Department of Planning & Development
Office of the Director

DATE: September 8, 2006
TO: Capitol Gateway Corridor BUILD Committee
FROM: Mark A. Olinger, Director
Department of Planning & Development
SUBJECT: Capitol Gateway Corridor BUILD Memo

First & Main: 3-4 story recommendation

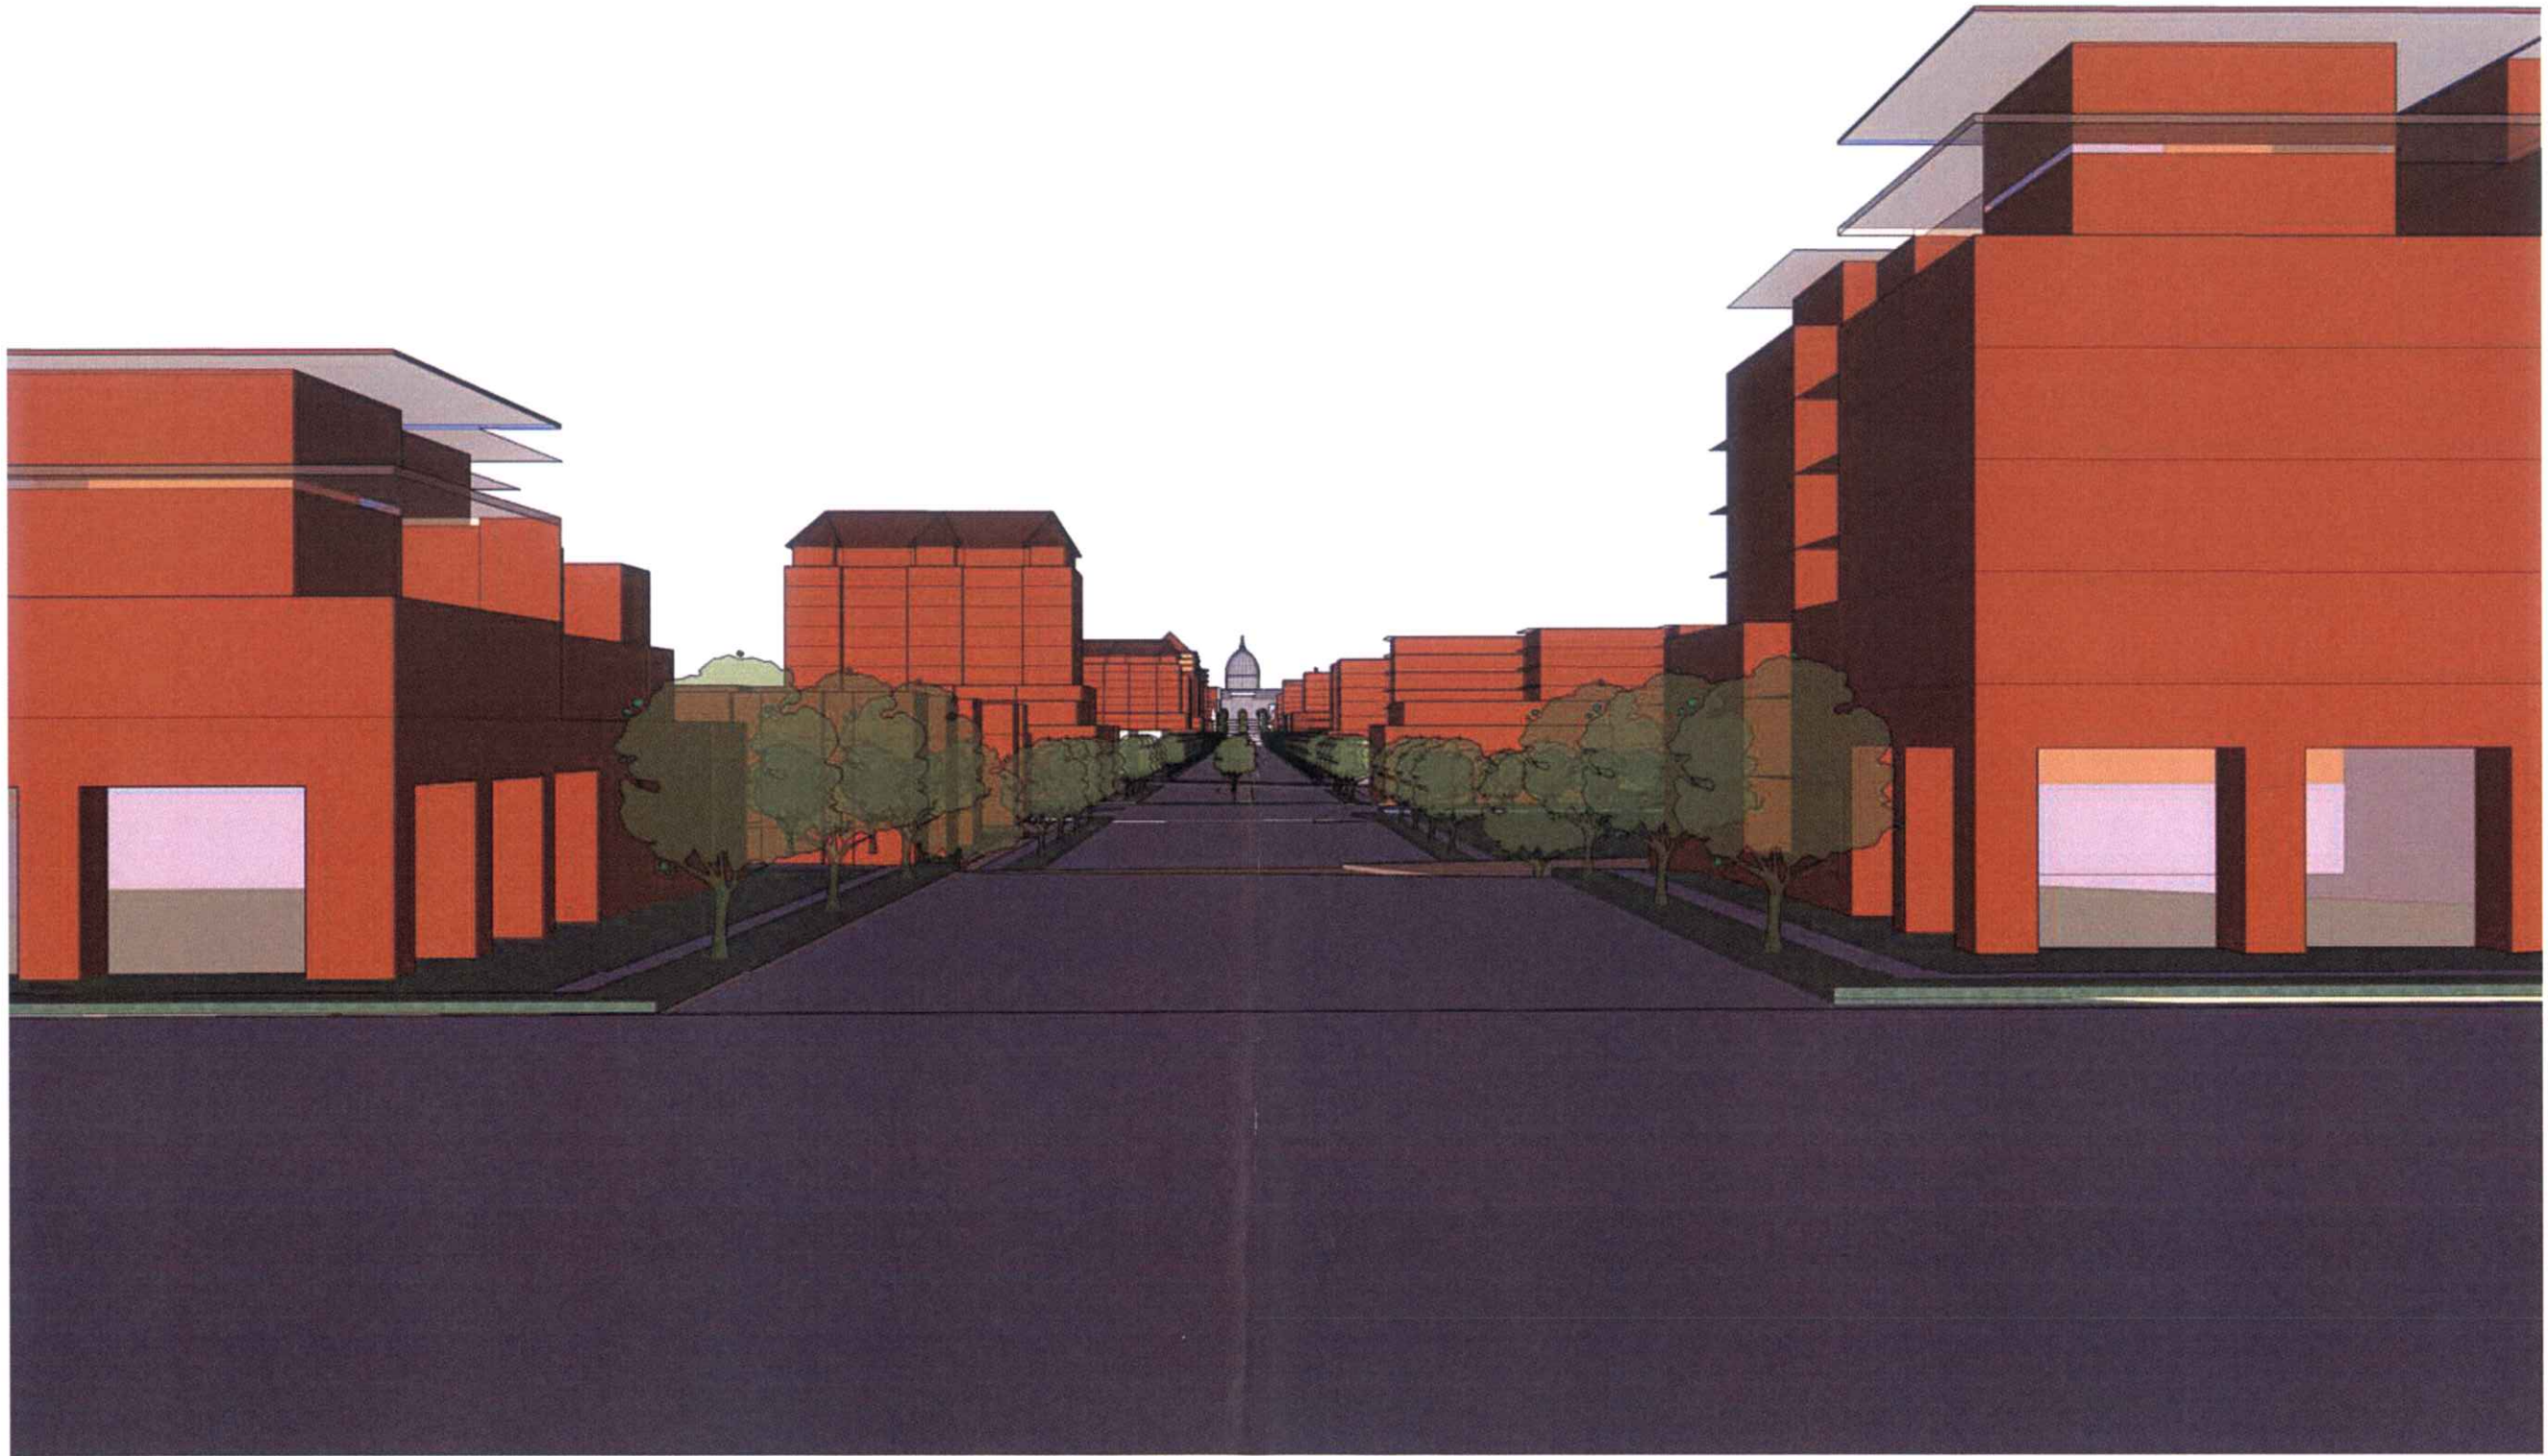
The intersection of East Washington and the Yahara River provides an interesting nexus of urban and natural resources. The challenge of that intersection is how we handle the interaction between these two resources. Department staff felt very strongly that development close to the river should be of smaller scale. That is why Blocks 8 and 17 had their boundaries adjusted – so that the scale would step down to the river. To show how that would look with the 3-4 story staff recommendation versus the 8-story draft recommendation, we have included a series of sketch-up massing studies for your review.
